CITY OF TACOMA
POWER GENERATION ENGINEERING

ADDENDUM NO. 02

Request for Proposal Specification No. PG21-0626N

Cushman #1 Right Abutment Access Road Remediation

NO.	DATE	REVISION DESCRIPTION	DRAWN	CHECKED	STAMPED
CITY OF TACOMA DEPARTMENT OF PUBLIC UTILITIES LIGHT DIVISION					
CUSHMAN 1 DAM RIGHT ABUTMENT ACCESS RD. EROSION REMEDIATION PLAN & LAYOUT					
REVIEWED			DESIGNED KES	DRAWN JCH	
APPROVED			7/21/21 DATE	STAMPED SDF	
			DRAWING NO. BP308

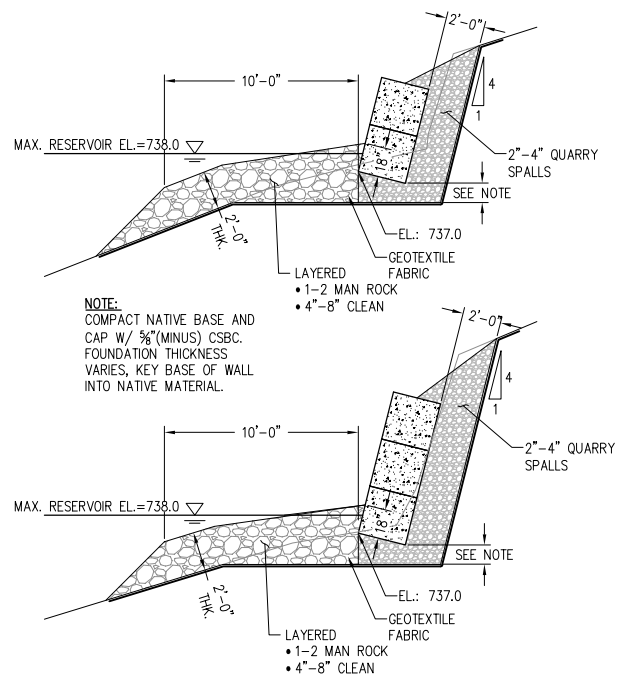
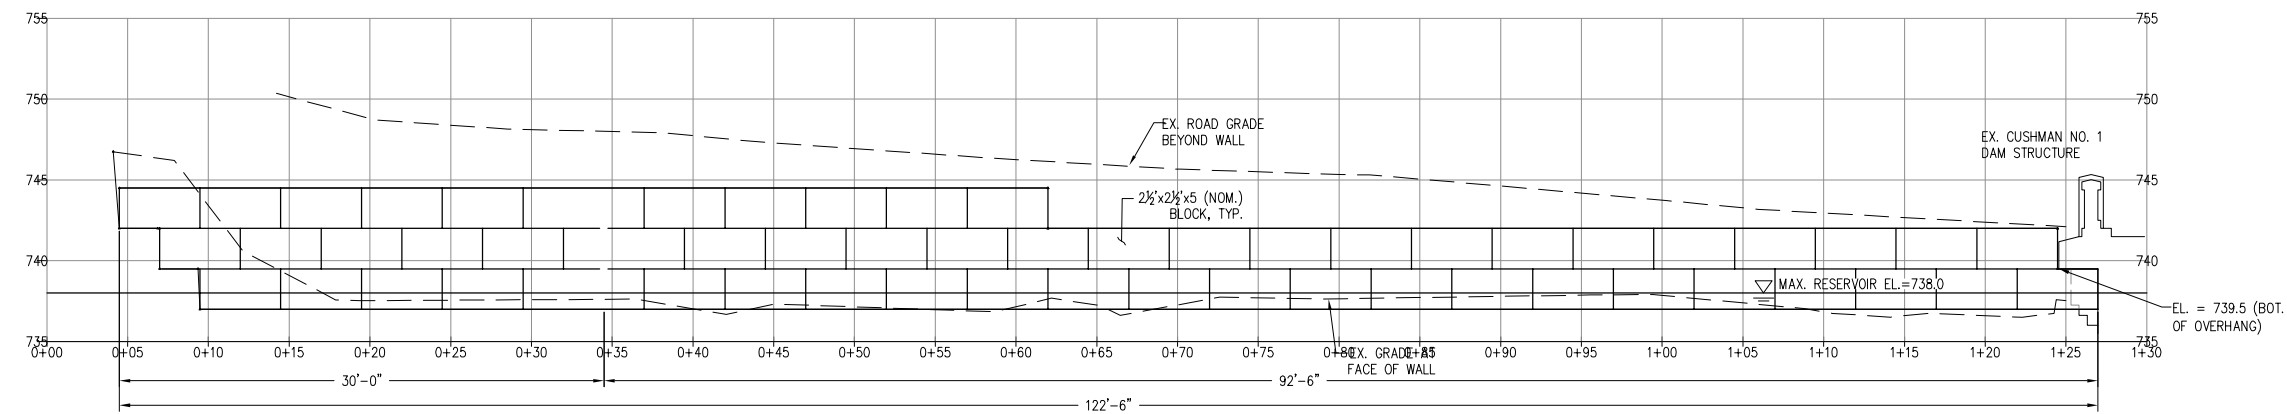
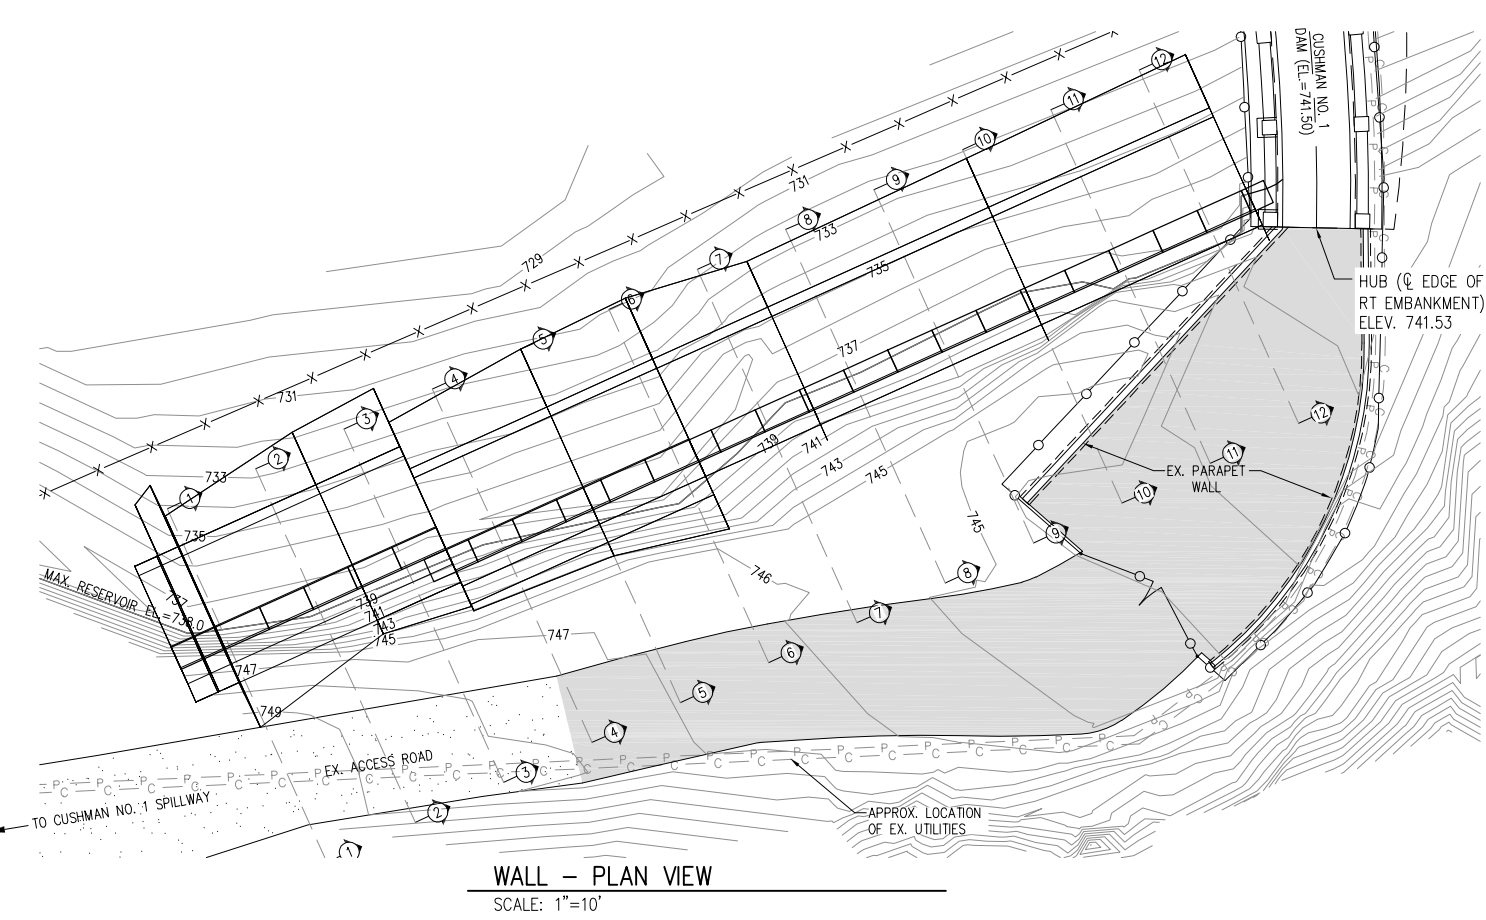
Replace Plan sheets BP-308 and BP-309

- NOTES:
- ELEVATION AT CL OF ABUTMENT AT EDGE OF ASPHALT 741.53 T.C.L. APPROXIMATE LEVEL OF LAKE CUSHMAN AT TIME OF CONSTRUCTION IS 720 T.C.L.
 - GRAVEL BACKFILL FOR WALLS SHALL MEET WSDOT STANDARD SPECIFICATION SECTION 9-03.12(2)
 - CRUSHED SURFACING BASE COURSE SHALL MEET WSDOT STANDARD SPECIFICATION SECTIONS 9-03.9(3)
 - QUARRY SPALLS SHALL MEET WSDOT STANDARD SPECIFICATION SECTION 9-13.1(5)
 - 1-2 MAN WALL ROCK SHALL MEET WSDOT STANDARD SPECIFICATION SECTION 9-13.7(1)
 - EXCAVATED MATERIAL TO BE USED AS FILL MATERIAL TO WIDEN EXISTING ROAD. EXCAVATED MATERIAL TO BE STORED ALONG EXISTING SERVICE ROAD.
 - CONCRETE BLOCKS SHALL BE SIMILAR IN APPEARANCE AND COLOR. BLOCK WILL HAVE BATTER OF 4V:1H. BLOCK WILL BE PLACES AND 1'-0" COMPACTED BASE OF CRUSHED SURFACING.
